A Review of the Millstone Nuclear Power Station Response to the USNRC
RAI of 8/12/96 on Fire Barrier Ampacity Derating

A Letter Report to the USNRC

March 27, 1997

Prepared by:
Steve Nowlen
Sandia National Laboratories
Albuquerque, New Mexico 87185-0737
(505)845-9850

Figure 3.1:

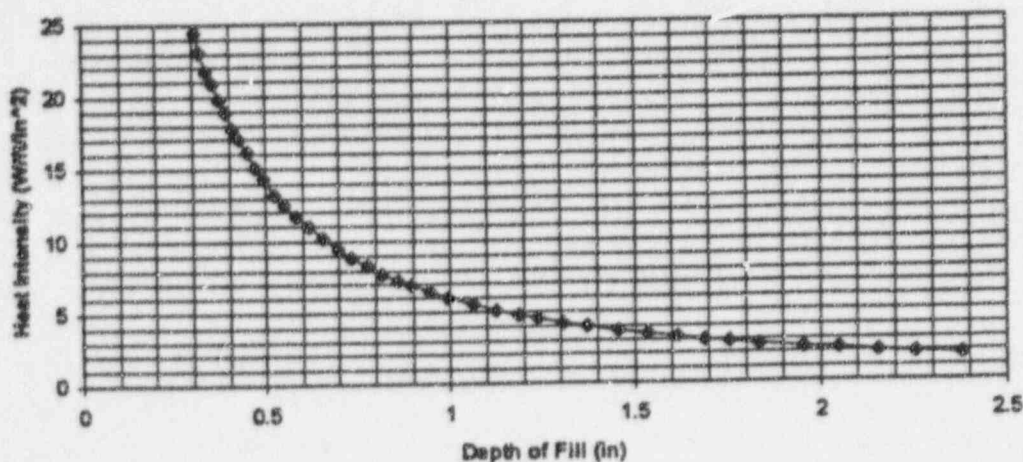
For illustrative purposes, SNL has reproduced the Stolpe heat intensity results as Figure 3.1 here. In producing this plot, SNL has simply digitized the original Stolpe plot for a 90°C cable as presented in his own Figure 4. For illustrative purposes, SNL has converted the "x-axis" from "percent tray fill" to "depth of fill" knowing that Stolpe's percentages were based on a 3" tray height. Hence, depth of fill is simply given by:

Also to make interpolation easier, SNL has plotted the results on a linear-linear scale as compared to Stolpe's original log-log scale. However, the data remains unchanged. The

licensee could easily replace the majority of its thermal model implementations with a citation to this or a similar plot of Stolpe's original heat intensity limits.
